ADDITIONAL INFORMATION MEMO

TO: Hingham Conservation Commission, Attn: Heather Charles Lis, Assistant Conservation Officer
FROM: Brad Holmes
DATE: August 31, 2020
RE: 42 Popes Lane, Hingham

- 1.) ECR Schematic

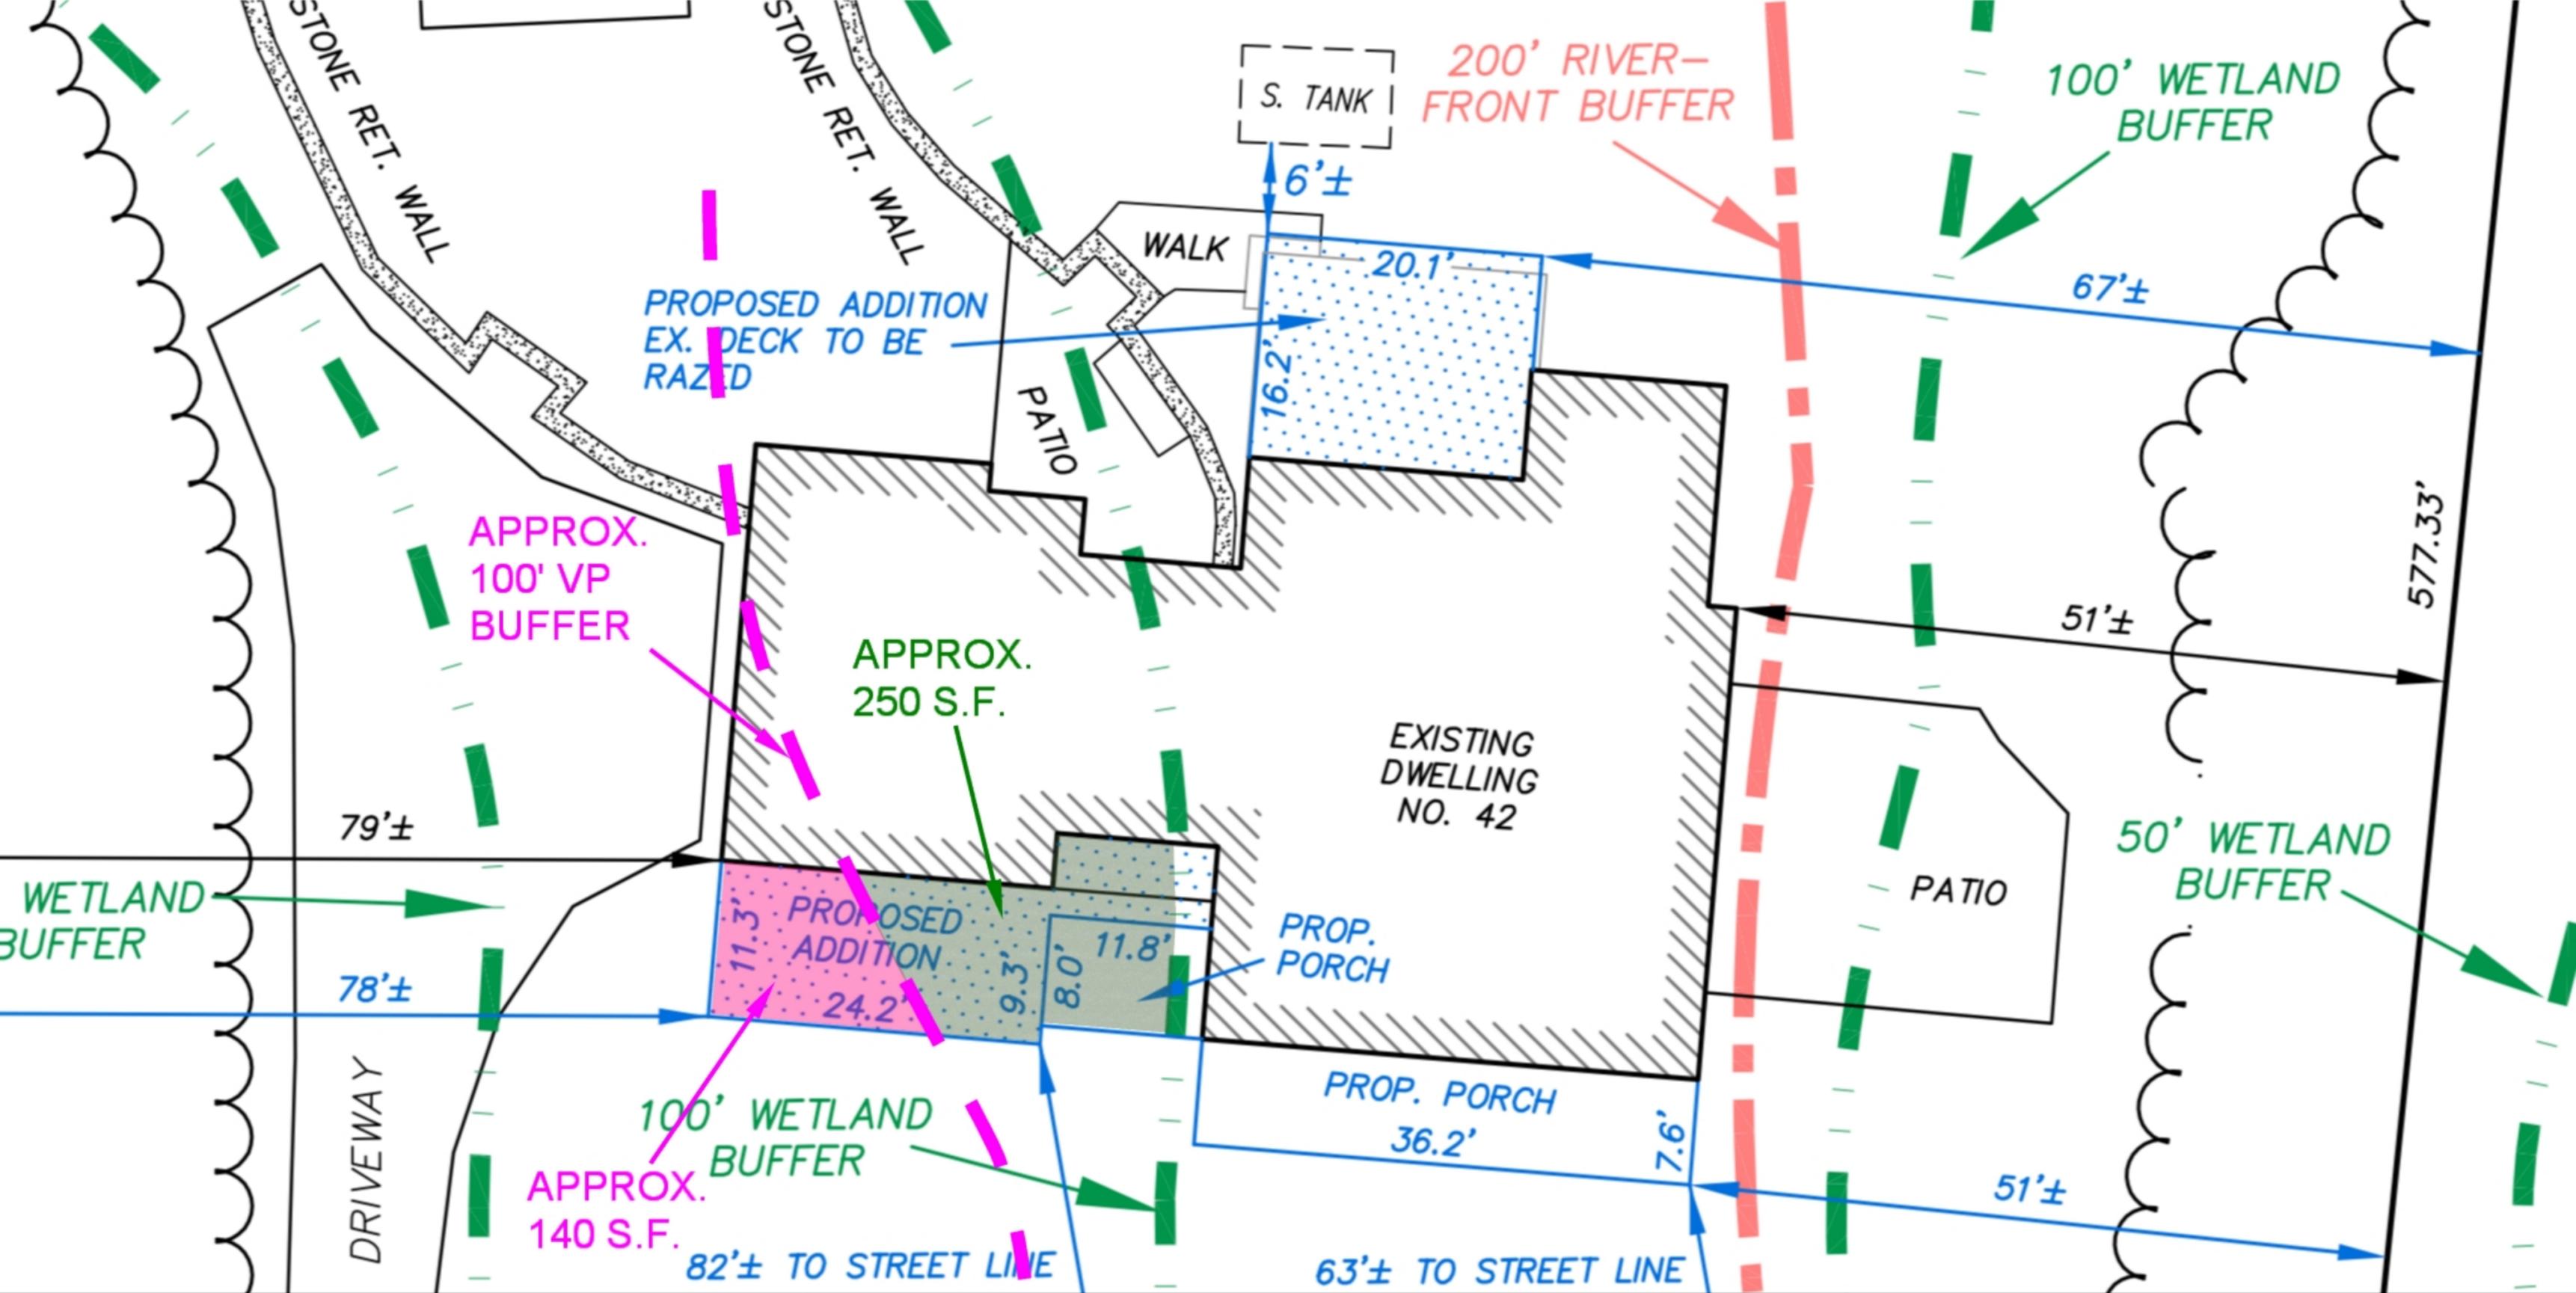
- *The 50 & 100-ft buffers to the Certified Vernal Pool should also be shown on the plans. I understand the BVW edge is closer to the proposed work, however the bylaw regulations have additional protection for Vernal Pools and their buffer zone so it is important to know where the limit is.*

- *The bylaw has a 100-ft "no disturb" buffer around Vernal Pools. If the Commission were to approve the proposed work, they would likely seek mitigation. They typically look for 2:1 mitigation planting area to area of new structure in the 100-ft buffer to a Vernal Pool, and then 1:1 mitigation for work within the 100-ft buffer to BVW (outside the 50-ft). Please provide a breakdown of the footprint of new structures (addition & porch) in the 100-ft buffer to the Vernal Pool, and then the portion of the structures that is outside this area, but still within the 100-ft buffer to BVW. Let me know if this doesn't make sense or you have any questions.*

- *Similar to the last comment, please quantify the area of new driveway proposed in the buffer zone to the Vernal Pool and to the BVW.*

- *Were other alternatives considered, such as shifting the driveway slightly to move it completely out of the RA? Staff would also like to add that it's not clear if the end of the driveway would be in an existing dirt driveway/path or in a wooded and naturally vegetated area.*

The buffers from the Certified Vernal Pool are included on the attached schematic. For calculation purposes, ECR has prepared this schematic showing the 100-foot buffer zone from the Vernal Pool within the proposed work area. ECR was able to calculate the area of proposed structures within the buffer to the Vernal Pool

and BVW using this schematic. Approximately 120 s.f. of new structure is proposed within the outer limit of the Vernal Pool buffer and approximately 250 s.f. outside the Vernal Pool buffer but within the BVW buffer. As you can see, this area of proposed work is at the front of the existing house, which offers little habitat value. This proposed work will not adversely impact the off site vernal pool and buffer zone.

ECR has created the attached schematic showing the 100-foot buffer zone from the Vernal Pool within the proposed work area. As stated previously, this area of proposed work is at the front of the existing house, which offers little habitat value. The addition is proposed within an area that currently exists as maintained lawn & landscaped beds, and therefore no planting areas have been proposed to mitigate the impacts to the lawn & landscaped areas.

ECR has calculated that approximately 1,060 square feet of the proposed driveway is located within the outer limit of the buffer zone to the Vernal Pool. Approximately 315 square feet is located outside the vernal pool buffer zone but within the BVW buffer zone.

The project has been designed to avoid adverse impacts to all wetland resource areas on and near the site. Approximately 12 square feet of Riverfront Area are proposed to be impacted by the proposed driveway. As proposed, the permanent alterations within the Riverfront Area will be negligible, and as a result, will not have an adverse effect as defined in 310 CMR 10.23: "Adverse Effect means a greater than negligible change in the resource area or one of its characteristics or factors that diminishes the value of the resource area to one or more of the specific interests of M.G.L. c. 131, § 40, as determined by the issuing authority. Negligible means small enough to be disregarded."
